# INITIAL FIRE SAFETY INSPECTION REPORT

## Oxford Knit Composite Ltd. (Extension)

RSC ID: 26360

Date: 24 June-2025

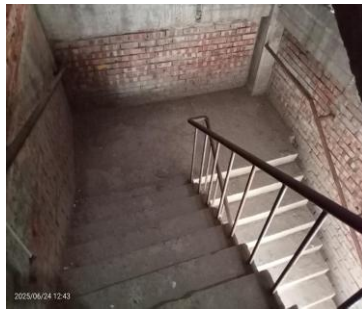
SI No.	Category	Findings	Required Action	Remediation Time Frame
F-1	Means of Egress	The exit stair enclosures are not separated from work areas and other spaces on each floor by fire-rated construction.	<p>The exit stair enclosure shall be provided with a minimum 1-hr fire resistance rating for buildings with 3 or fewer stories and a minimum of 2- hr. fire resistance rating for buildings 4 or more stories. Provide 1-hr. fire rated door and seal all penetrations and openings by 1 hr. fire rated fire rated barrier construction for building with 3 or fewer stories. Provide 1.5 hr. fire rated door and seal all penetrations and openings by 2 hr. fire rated fire rated barrier construction for building with 4 or more stories in accordance with section 6.3.1.2 of RSC Technical Guidelines (Standard)<sup>1</sup> V1.0.</p> <p>Provide a fire-resistive rated assembly between the exterior exit stairs and the building up to 10 ft. beyond the end of the stair to achieve the required separation. The rated assembly shall be approved and/or designed by a qualified fire protection engineer.</p>	Within 3 months
